**Response to Comments
on
EPA Draft 2020 Permit Modification to the 2016 Reissued RCRA Permit and
Associated Statement of Basis for EPA’s Remedial Action for the “Rest of River”
Portion of the Housatonic River**

GE-Pittsfield/Housatonic River Site

December 2020

U.S. Environmental Protection Agency
Region 1 (EPA New England)

**FIGURE 1
UPLAND DISPOSAL FACILITY,
SITE LOCATION MAP**

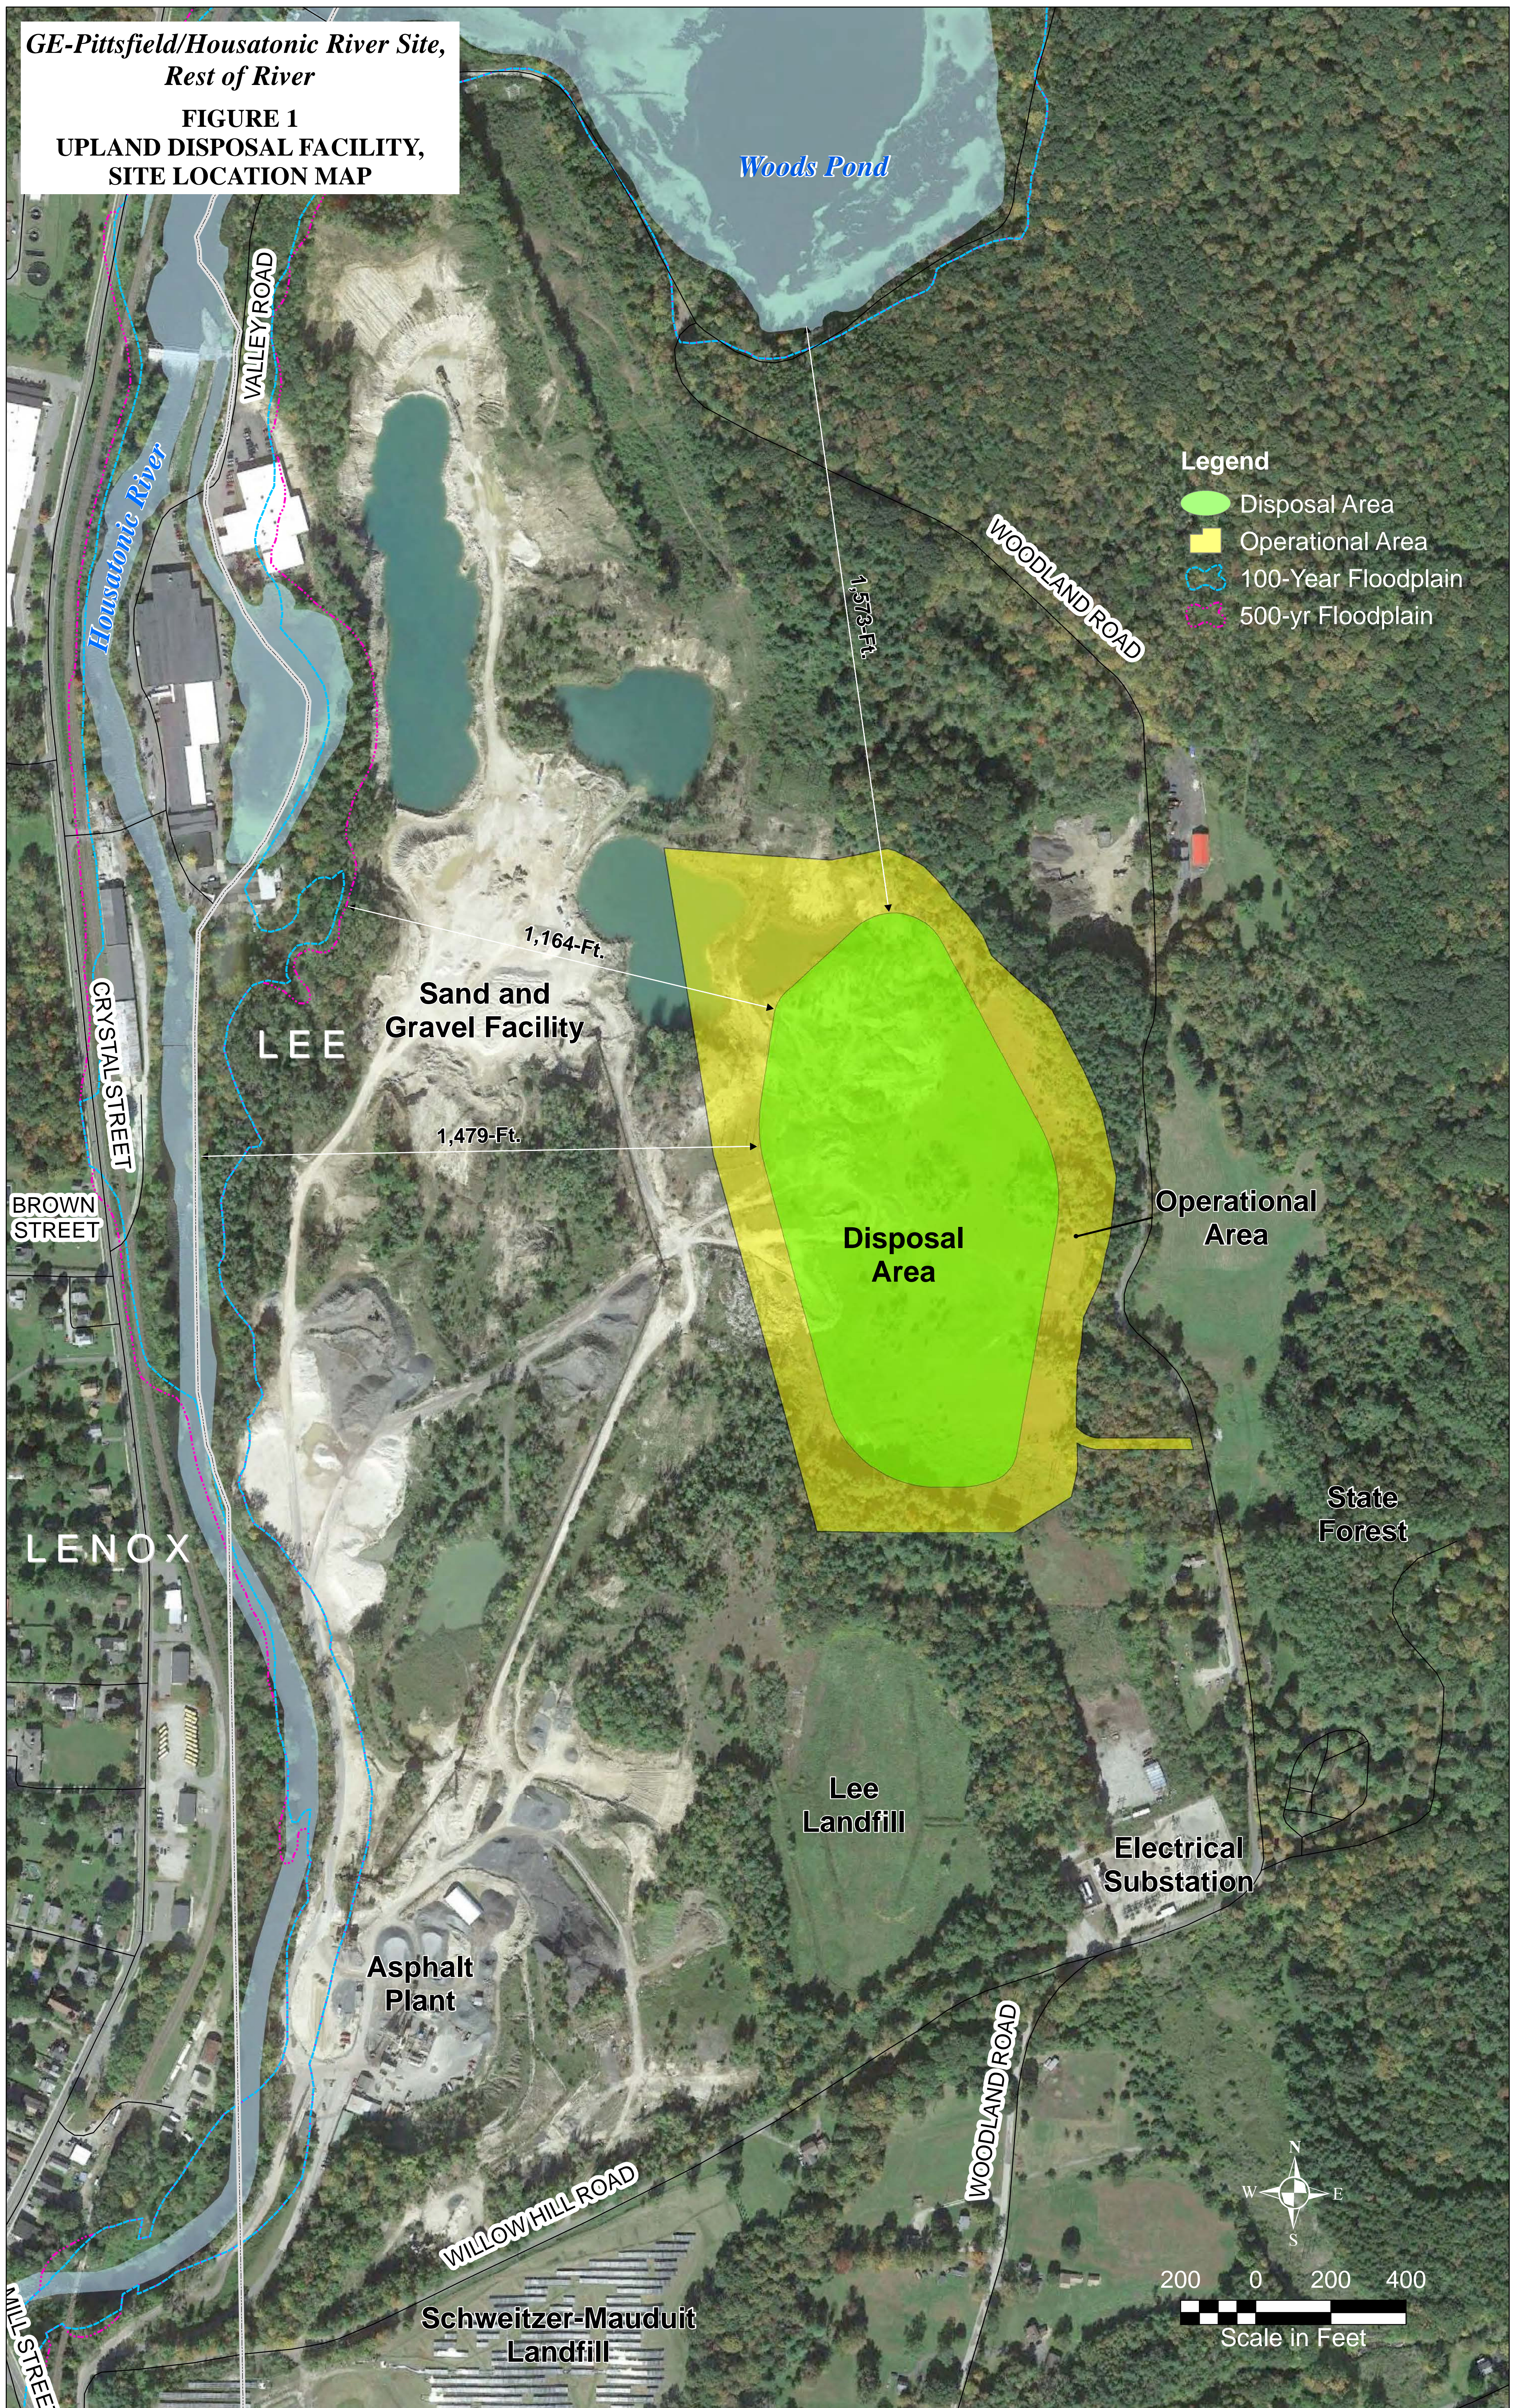
Comment II.A.1: Several commenters expressed strong opposition to the proposed UDF location. Specific comments in this category cited the consistent vehement community opposition to local disposal; air emissions and risks to the community during and after construction; concerns about frost effects, seismic activities/earthquakes, or extreme weather events on the UDF; the suitability of soils at the location for a landfill and contamination of groundwater; and the potential for re-contamination of the River from a failure or leaking of the landfill.

description of the UDF location to mean that wastes were being piled along a steep bank along the River. To the contrary, the UDF location is over a ¼-mile from the River and is well outside the 500-year floodplain (which is located 1,164 feet from the disposal area). Figure 1.

Regarding questions relative to the suitability of soils underlying the UDF location, it is first important to note that two other landfills already exist in this immediate area. Figures 1 and 2. Neither of those existing landfills have the benefit of a bottom liner, whereas the UDF will have a double bottom liner and leachate collection system. The UDF's liner system is protection against concerns regarding permeability of the underlying soils. For TSCA Chemical Waste Landfills, the regulations prescribe that a bottom liner be placed where underlying soils are permeable. 40 C.F.R. 761.75. The UDF will meet this requirement. Furthermore, state solid waste landfill regulations would allow the bottom of the landfill to be constructed to within 4 feet of the water table (310 CMR 16.40.3(a)(12)), whereas the Permit increases this buffer to no less than 15 feet. The underlying soil characteristics at this location have the added advantage of allowing the preparation of an ideal sub-base for proper grading, placement, and construction of the bottom double liner system. Permit, II.B.5.

- The proposed UDF is located in an industrial area that contains an asphalt plant, a sand and gravel pit, an electrical substation, and several commercial/industrial facilities and is near two closed landfills. The UDF is bordered to the north and east by a large state forest. Figure 1.

**FIGURE 2
SURFACE WATER PROTECTION ZONE A,
LEE PUBLIC WATER SUPPLY**

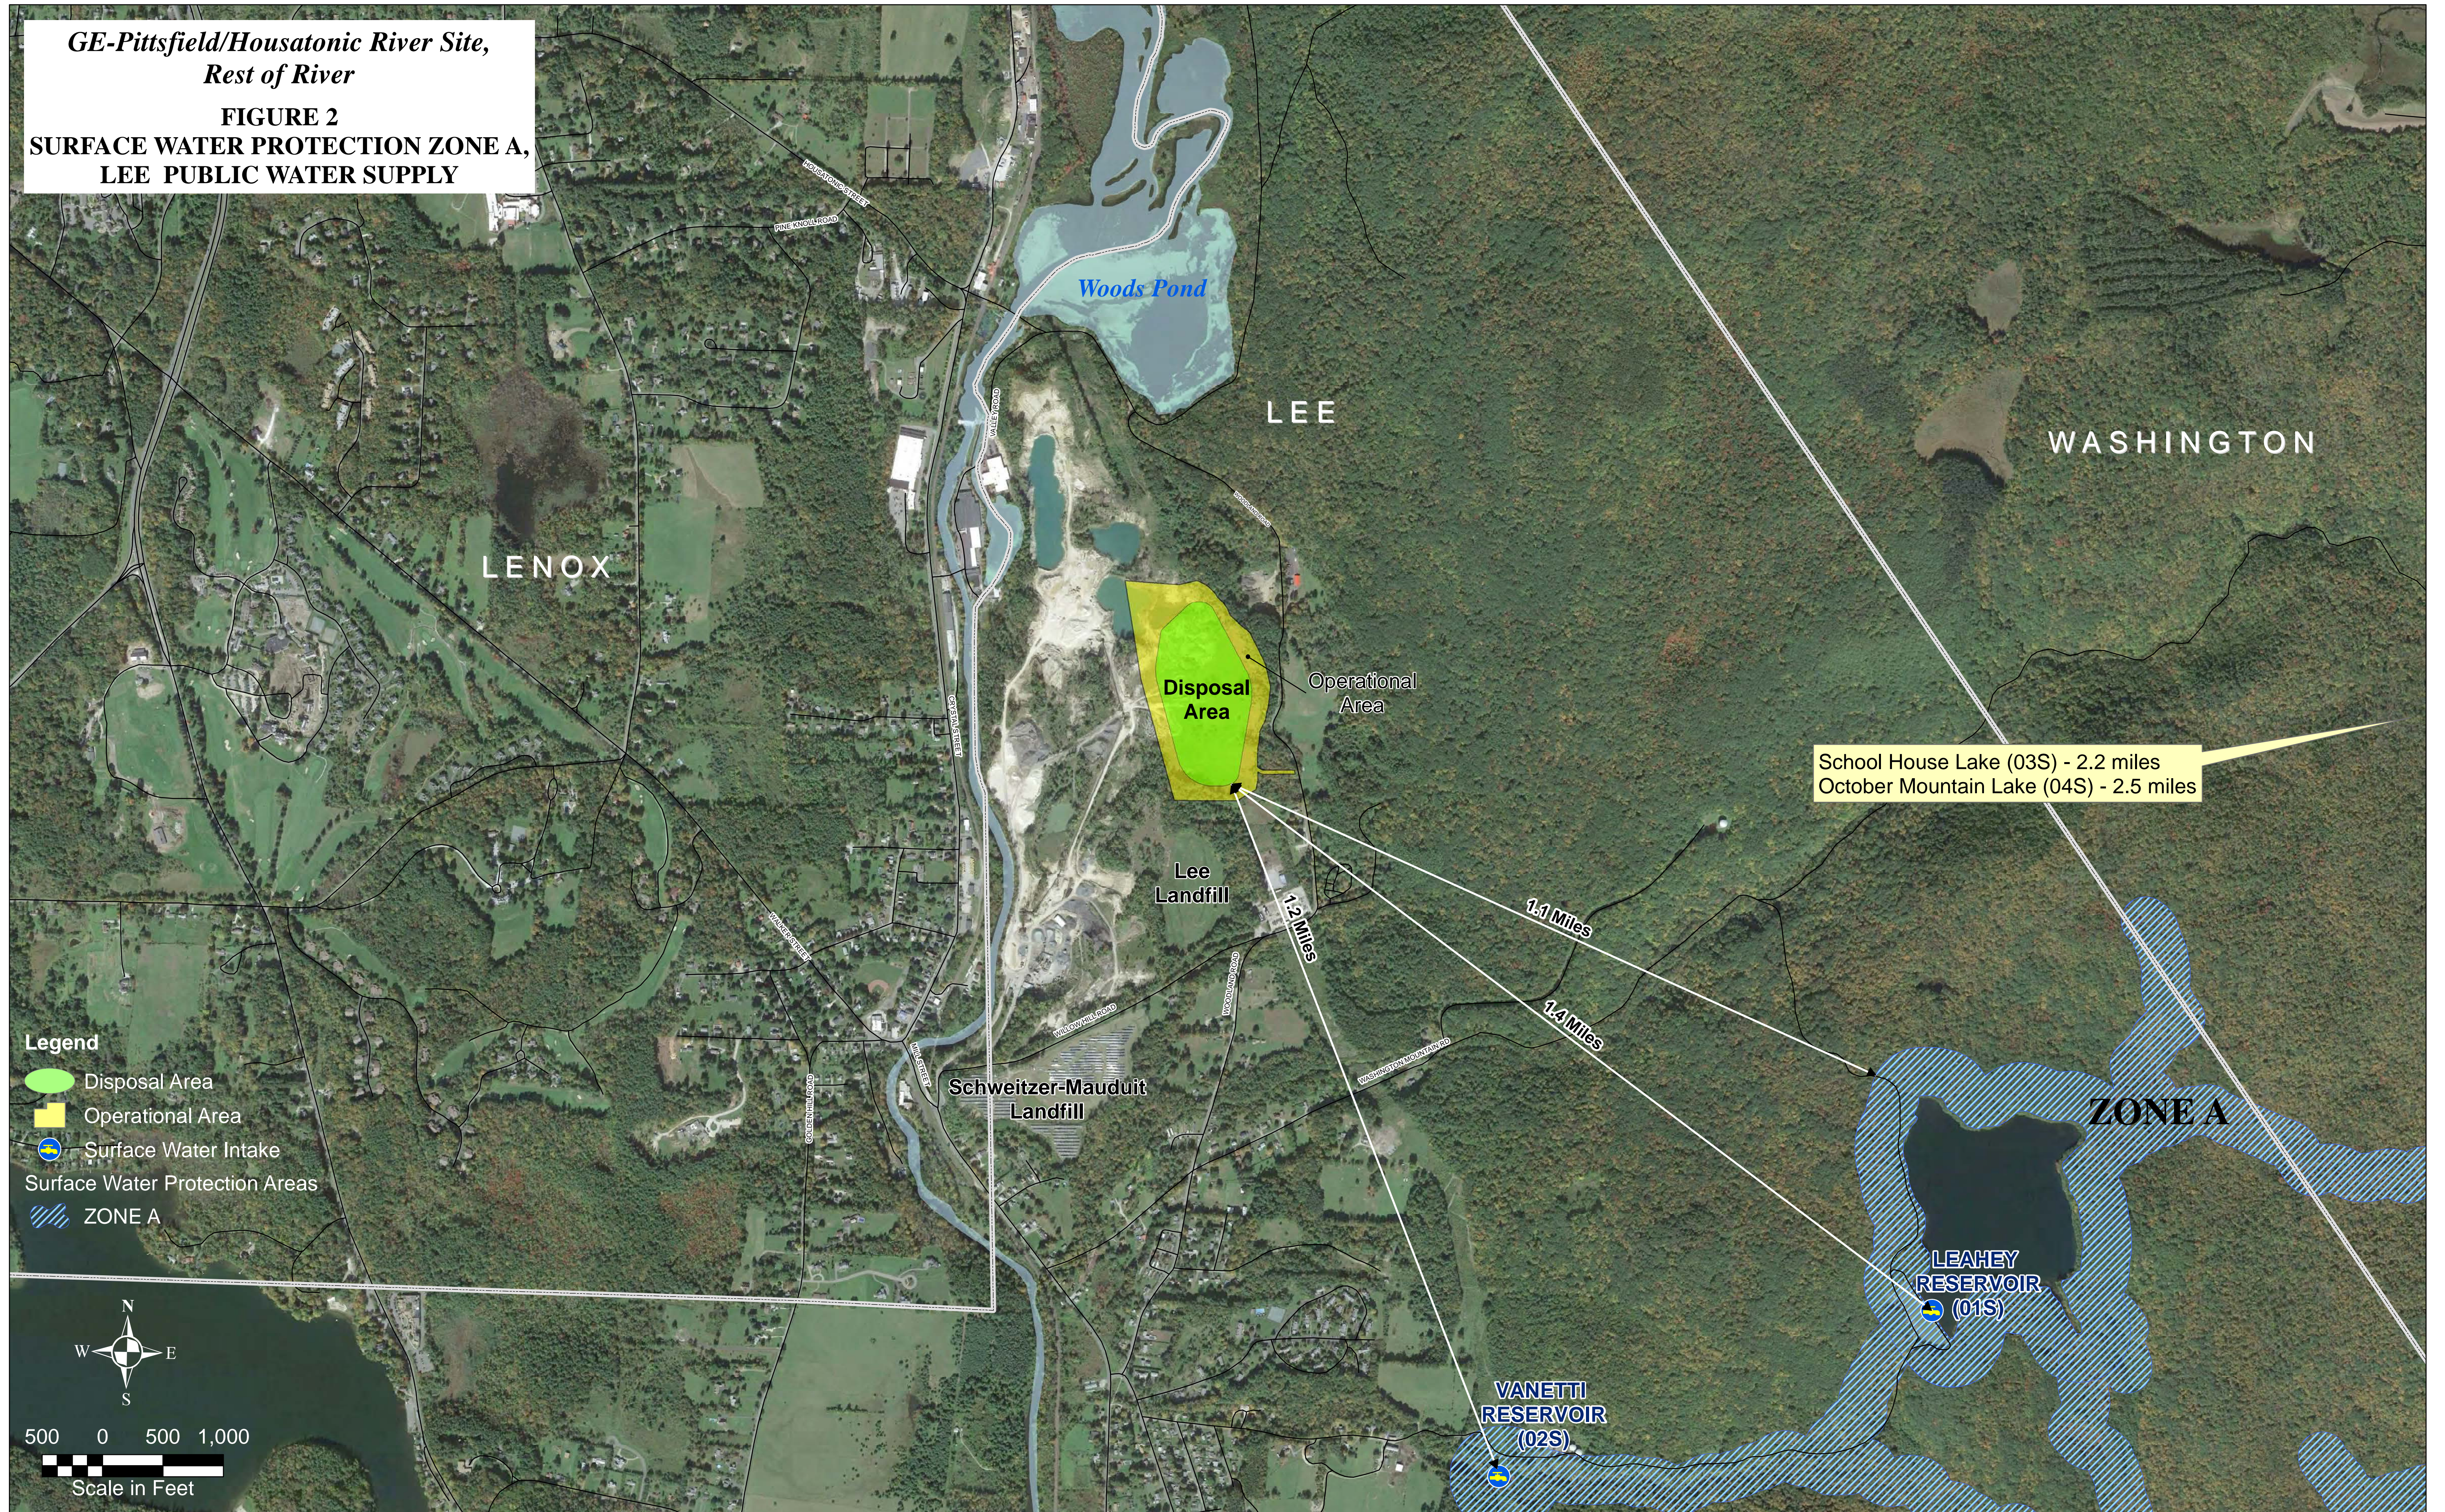
Comment II.A.5: Several commenters expressed concerns about impacts to local water supplies should a release occur. A number of commenters questioned the provisions for abandonment of

The UDF is also distant from drinking water protection zones. The Commonwealth of Massachusetts designates protection areas around all state water supplies to ensure that the water supplies are not affected by potential sources of contamination to the water supply. The following are the Surface Water Protection Zones that are used to provide increasing levels of protection:
